**Flood Control Project Maintenance
Levee Inspections**

Maintenance Issue Types Only, Levee Inspection Report By Mile - Fall 2018

Reclamation District No. 2064 River Junction

Waterway	Bank	Unit Miles	Inspection Start/End	Inspector
Unit No. 01 San Joaquin River	Right	5.56	10/05/2018 10/05/2018	Luz Dial

Photo 1 of 1 : FA_2018_RD2064_314_20_20180910_00003.jpg

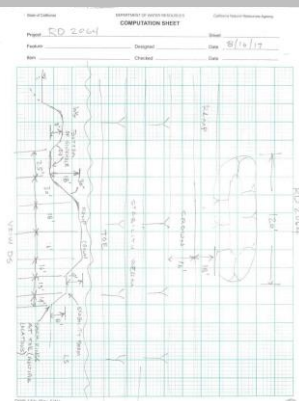
LM Start	0.71	Rating **	A/W	Issue No.	20
LM End	0.71	Issue Type +	Ma	Location *	
Category	Supplemental		GPS Latitude/Longitude		
			Start	End	
Item	2017 Storm Damage		37.664200 °	37.664200 °	
			-121.230420 °	-121.230420 °	
DWR ID	DWR_RD2064_02_f_2017_20				
Comment Code					
Inspector Comment					
Levee Evaluation Comments Description: POI is a waterside sinkhole with an existing seepage berm on the landside. This site was flood fought in 2017 with sack rings. Site ID No: 584 Site Designation: LMA-490 Repair Type: Stability Rating: Area of Concern Field Date: 8/16/2017 Notes: POI is a waterside sinkhole
